Addendum No. 1
Solicitation 26-990368
2026 Street Preservation – Morley Heights

This Addendum is issued to modify, explain or correct the original drawings, specifications and/or previous addenda and is hereby made a part of the Contract Documents.

PROJECT: 2026 STREET PRESERVATION PROJECT

PMH-403 PRE-TREATMENT MANHOLE (4)
NOT TO SCALE

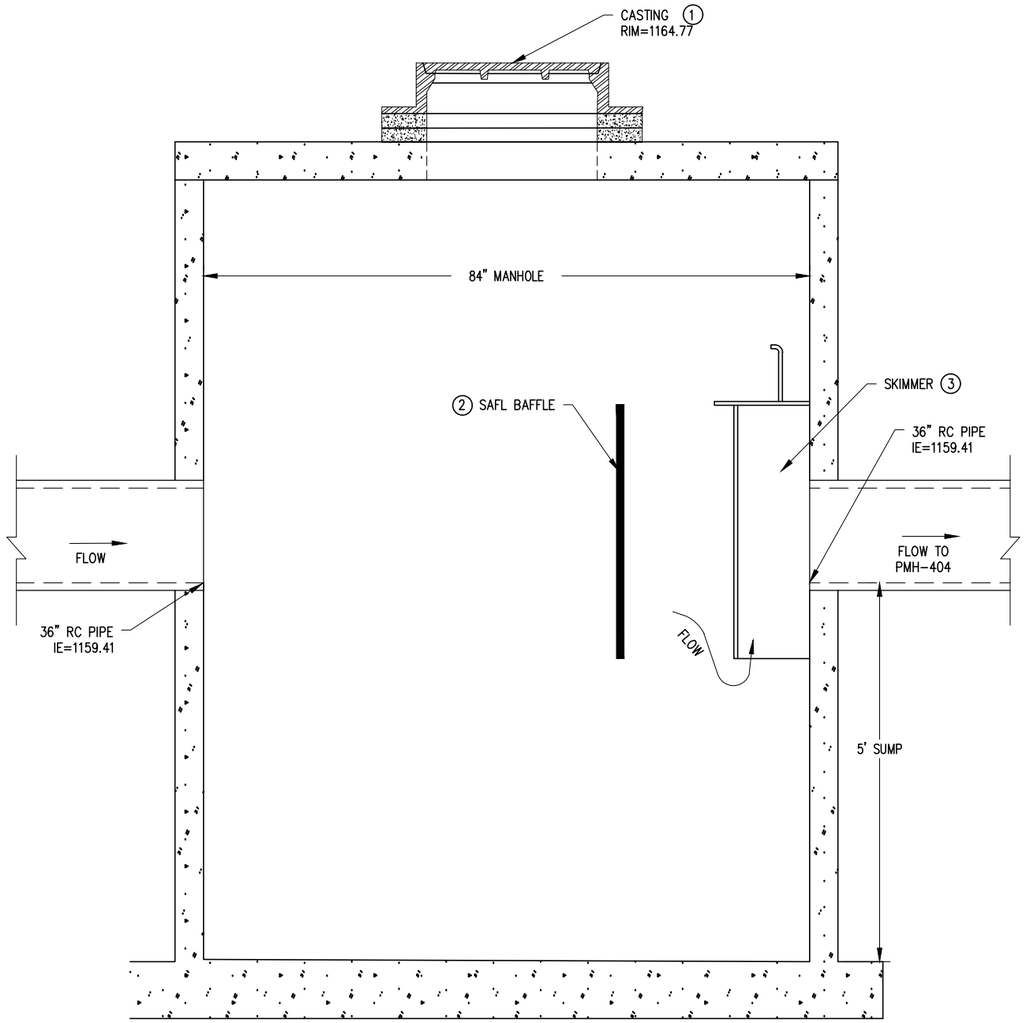
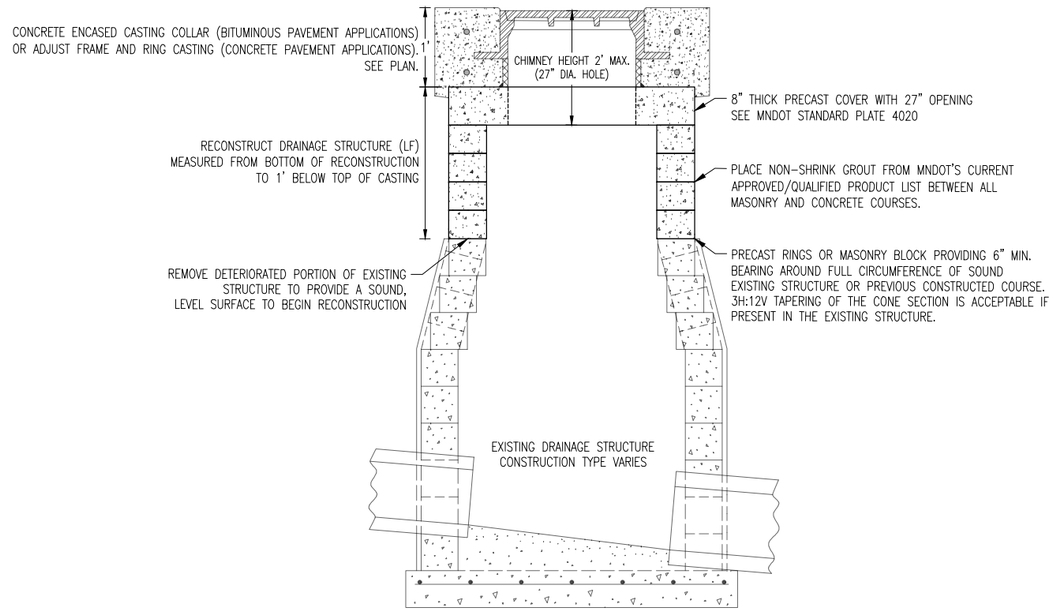
d. Section SP-34 (2506) CONSTRUCT DRAINAGE STRUCTURE DESIGN SPECIAL is hereby amended as follows:
    i. SP-34. Amend paragraph “Furnish and install 60” concrete Manhole per MnDOT 2506 and City of Duluth Standard Construction Specifications with sump per detail in plans” to say “Furnish and install **84”** concrete Manhole per MnDOT 2506 and City of Duluth Standard Construction Specifications with sump per detail in plans”. Initial manhole size was too small for internal components.
